CITY OF SAN LUIS
FINANCE WING RECONFIGURATION PROJECT AT CITY HALL
Bid Addendum #1

Date Issued: **2/22/24**

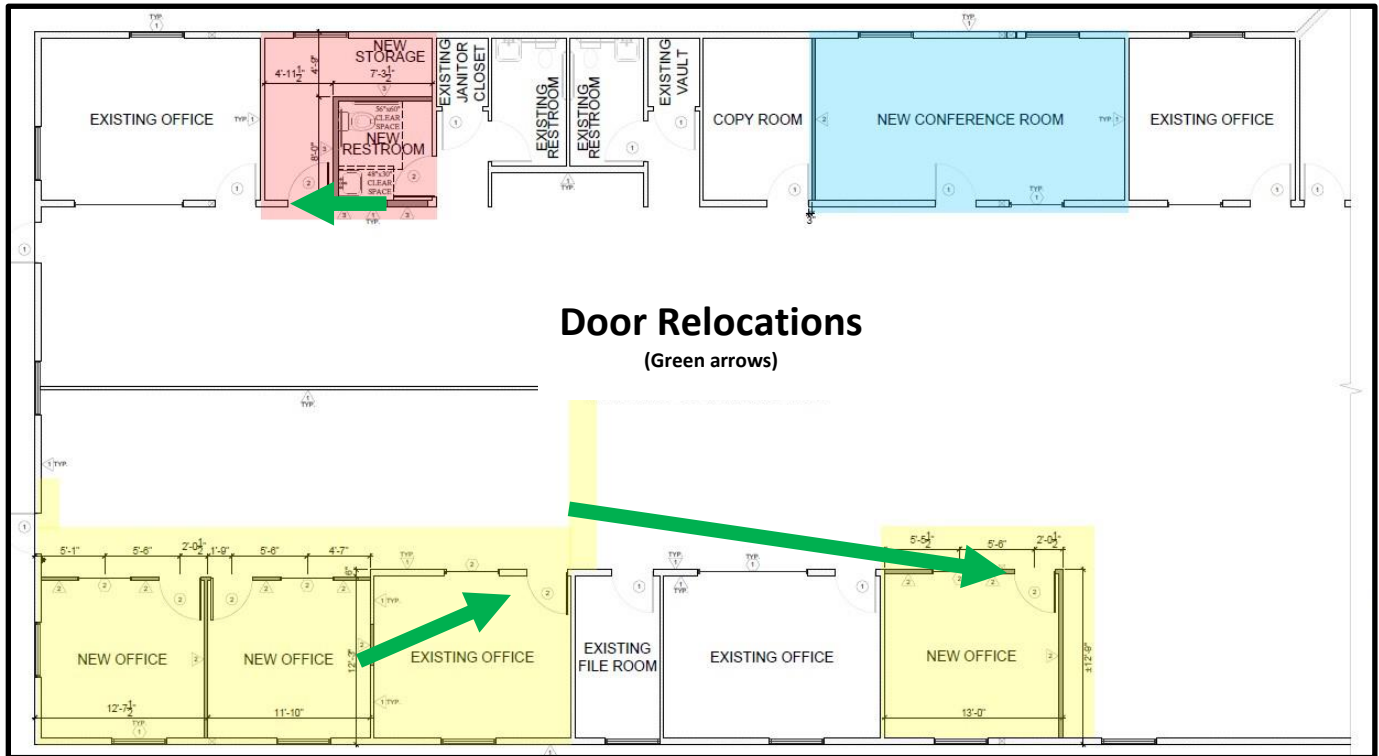
Question 2: Can existing door frames and doors be used in new locations? This will save some cost.

Response 2: Yes, doors and door frames can be utilized to save cost if doors swing in the same direction and follow code. Doors can be re-purposed in the following order: (See diagram below)

- Section 1: Existing office door that will be sealed (West wall of office) relocated to north wall of same office.
- Section 1: Door of wall that will be removed to be relocated to one of the three new offices.
- Section 3: Door in current office to be relocated in new storage room.

(3) New doors will be needed at: 2 new offices at section 1 and restroom door at section 3. Contractor to match door by Oshkosh Door, Oshkosh Series. If unable to find the exact door, the new door must be approved by City staff/coordinator.
